SOLANO COMMUNITY COLLEGE

AUTO TECH FACILITY

PROJECT DIRECTORY

24 ENLARGED STAIR SECTION
1/2" = 1'-0"

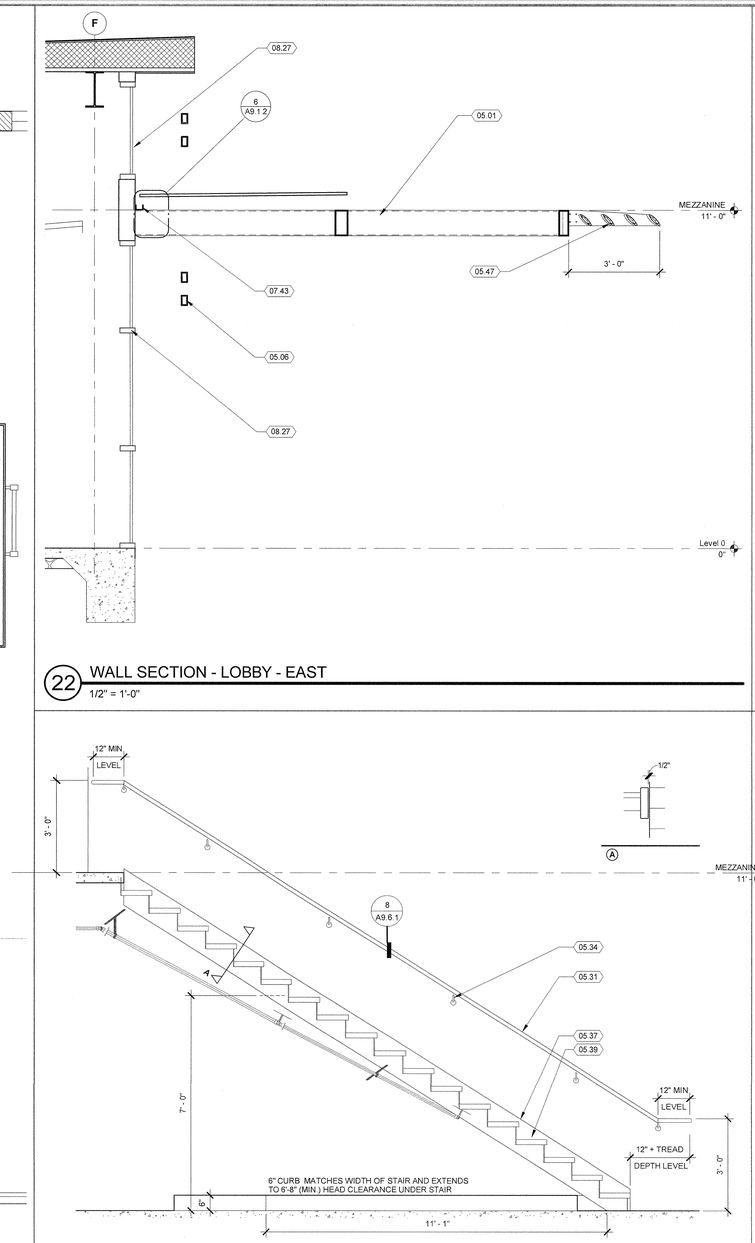
CCD#029 (ASI #016)

Roof Deck Plan (A / S2.2) — 1/16" = 1'-0"

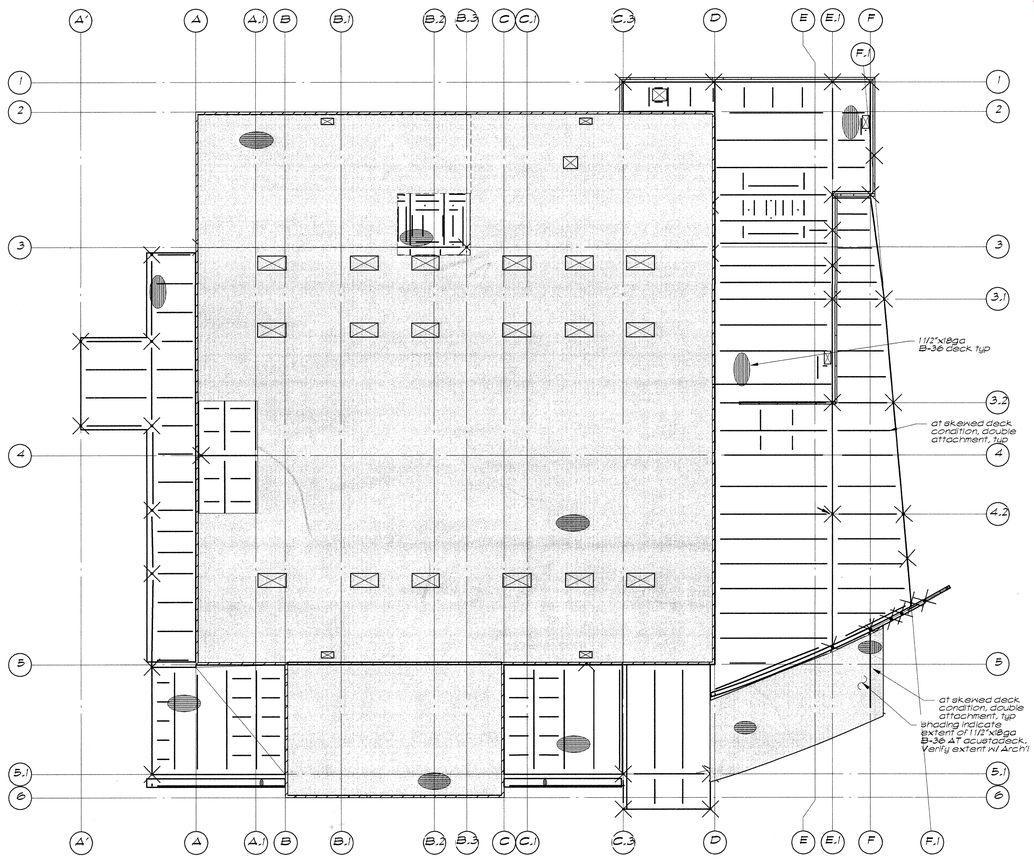
RFI#055
4 inches clean crushed drainrock beneath the concrete slab (w/ vapor barrier between drainrock and slab) acceptable. Drainrock should be placed via vibratory means. The 95 percent requirement is not applicable and compaction testing will not be performed.
